PLANNING COMMISSION

June 10, 2026 at 7:00 PM

Discussion of potential code amendments implementing Transportation System Plan

Date 7 May 2026
Subject Hermiston Transportation System Plan Update
From Marcy McInelly, AIA, Shelley Denison, AICP, Urbsworks, Inc.

PARTITION PLAT NO. _____
PARTITION PLAT OF A TRACT OF LAND, LOCATED
IN THE SW1/4 OF SECTION 11, T.4N., R.28E., W.M.,
UMATILLA COUNTY, OREGON
W. O. 26-6465

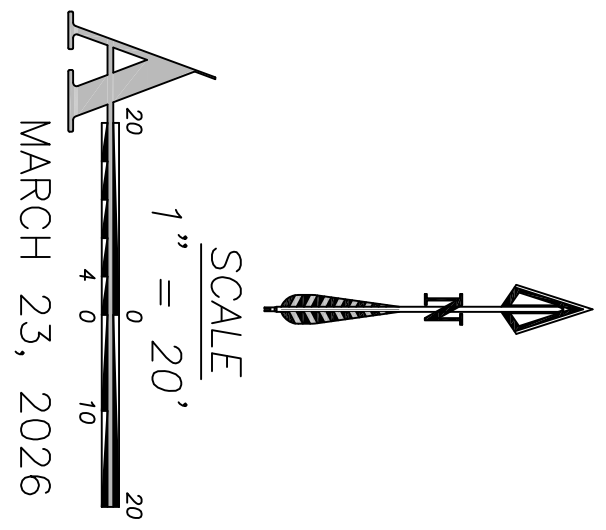
The planning commission moved to continue the discussion of the proposed minor partition plat at their May 13 meeting pending additional information from the applicant. The planning commission requested that the plat document the existing and proposed structures and their setbacks from proposed lot lines. The planning commission also seeks testimony regarding the plan for the existing garage, which appears to be within the rear and side setback of the proposed new lot area.

We have not received a response from the surveyor regarding the following requested plat corrections:

- width of SE 7th St
- surveyor signature

According to the supplemental information submitted by the surveyor, the ADU on Parcel 2 meets or exceeds all required setbacks. The existing garage has been issued a demolition permit and will be removed. It is the staff recommendation that the applicant has satisfied the planning commission's request for additional information.

Figure 154.XX - 01 - Residential Street Connectivity, Blocks, and Accessways

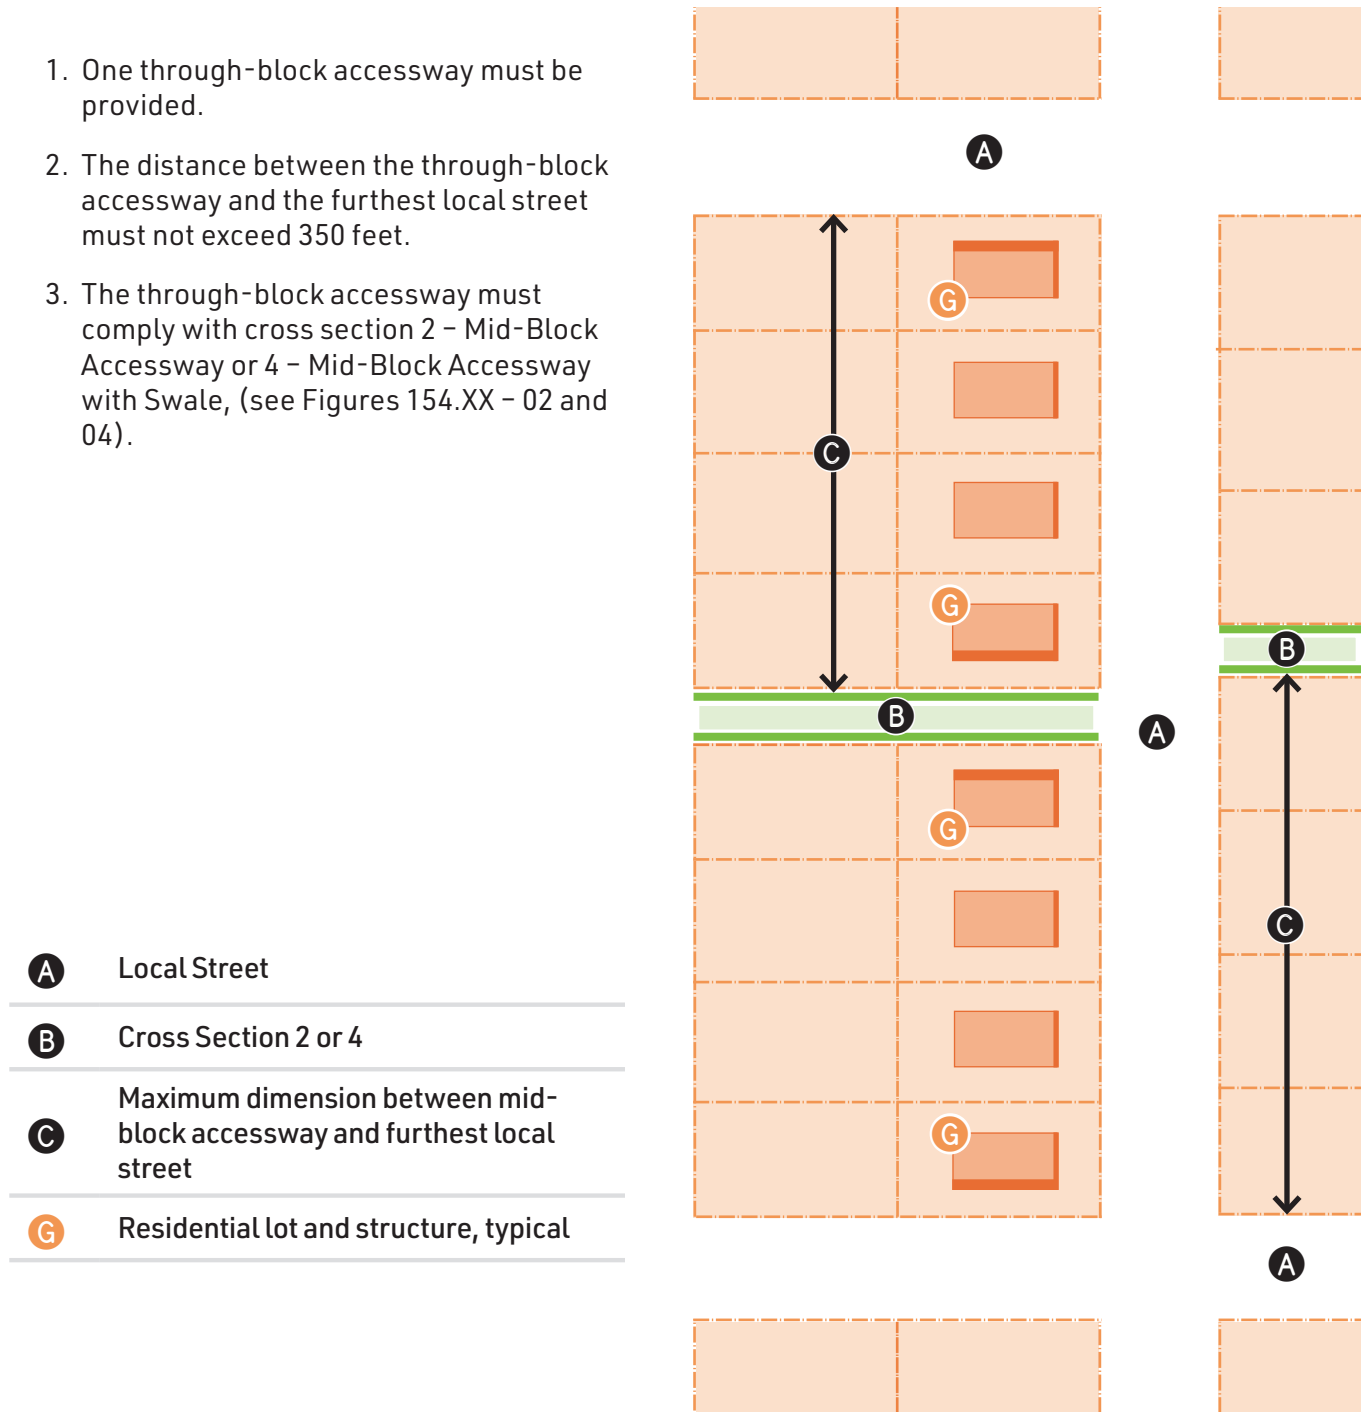
I understand that early in the scoping I wanted to explore narrow streets and we have done a great job exploring that option. However, in conversations with the fire chief and in our round table with the planning commission and city council, narrow streets were extremely unpopular. As far as I am concerned, these are a dead issue in this TSP and should be removed. Looking at the May 7th memo, I'm seeing the recommendation to amend the code to allow skinny streets serving less than 10 lots. Let's excise that. Following on removing the recommendation, please remove the skinny street figures 02 and 03. The mid-block diagrams are referenced as 2 and 4 but I just can't find a diagram.

Figure 154.XX - 02 | Narrow Street

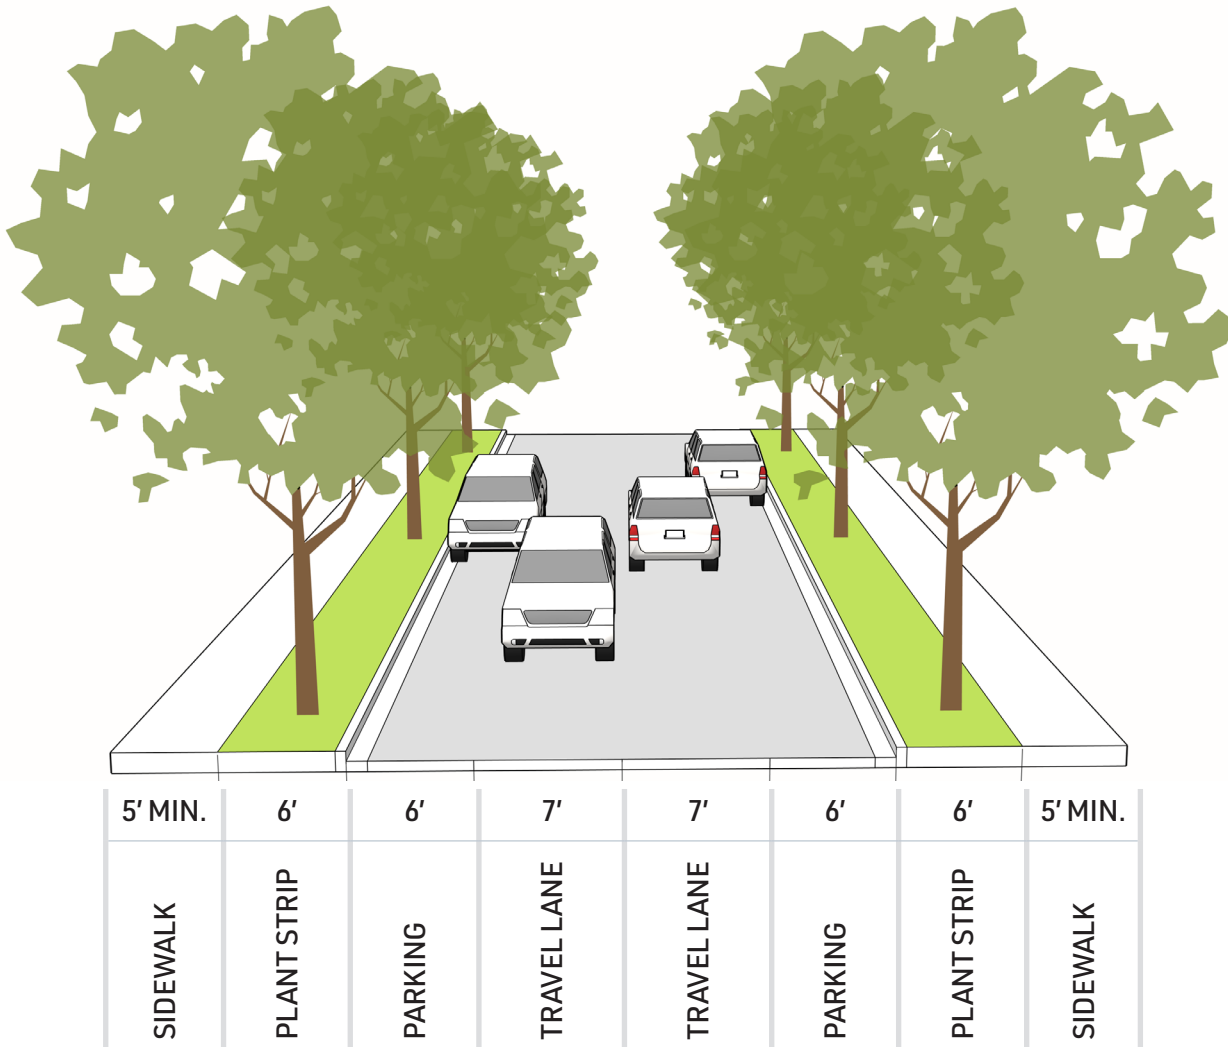
In attachment A please remove the narrow streets, yield streets, and queuing streets from the local residential section. Additionally, on page 2 of attachment A, please amend the statement regarding sidewalks on one side to clarify that this applies only to mid-block accessways to avoid confusion with developers wanting to sidewalk one side of the street only throughout the development. I've floated this idea with our development staff and planning commission and one side sidewalks are a non-starter with both groups.
